DSC-100 RoHS

DSC-100 (OLD)

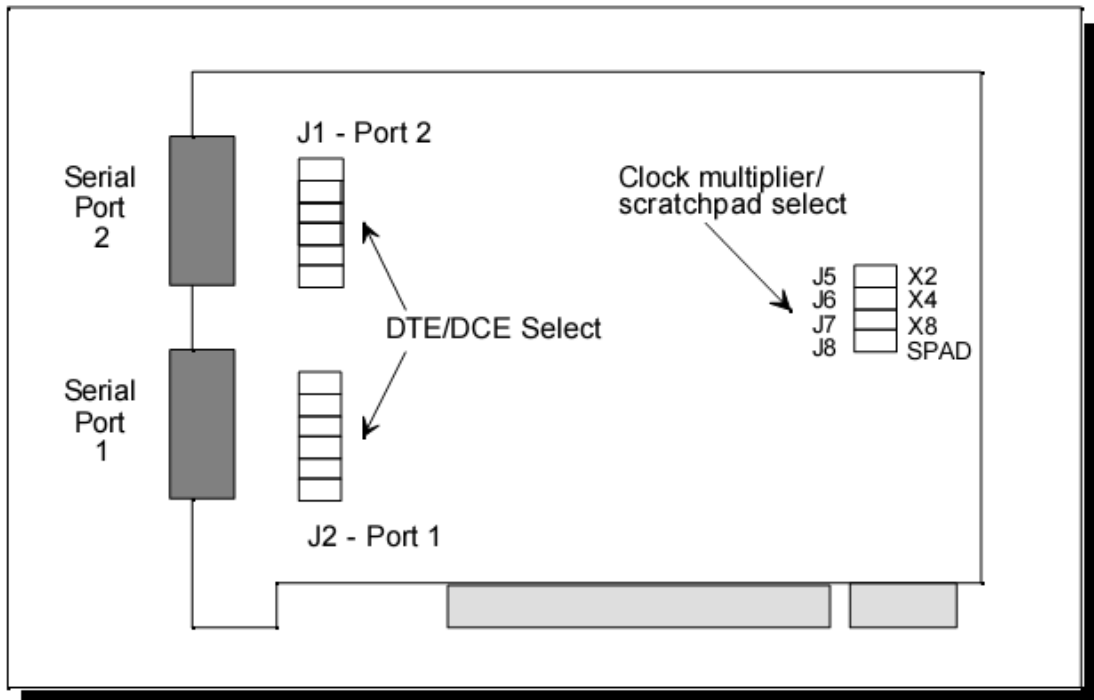
Jumpers J1 and J2 are removed on the new card.

These jumpers were used to change the card from a standard DTE device to a DCE configuration.

Jumpers J5-J8 labels have been removed on the new card.

On the new card, the top selection is SPAD, and then moving downward, X8, X4, and X2.

If for some reason a DCE configuration is need, simply use a null modem cable.
